RZP-2021-087

1701 AMHERST PL, CHARLOTTE NC 28204

[Discipline: CHARLOTTE WATER]

Novant Health Rezoning Petition No. 2021-08

SCHEMATIC SITE PLAN

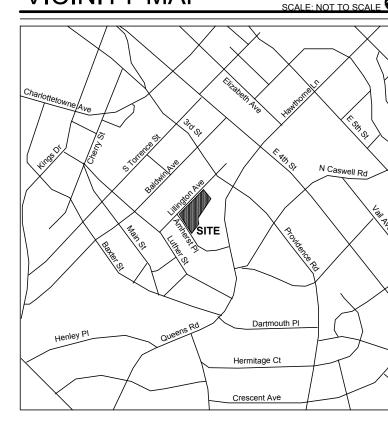
Summary: Water and sewer service is accessible for this rezoning boundary.

Charlotte Water has accessible water system infrastructure for the rezoning boundary via an existing 6-inch water distribution main located along Lillington Av.

Charlotte Water has accessible sanitary sewer system infrastructure for the rezoning boundary via an existing 8-inch gravity sewer main located along Lillington Av.

Development is encouraged to contact Installation Development Services at (704) 336-5499 to review service connection design requirements and City Ordinances (e.g., backflow, separate meter Ordinance, public/private pipeline extensions). Comments: Has direct access to sewer. Has direct access to water. Contact CLT Water New Services Department for water/sewer services.
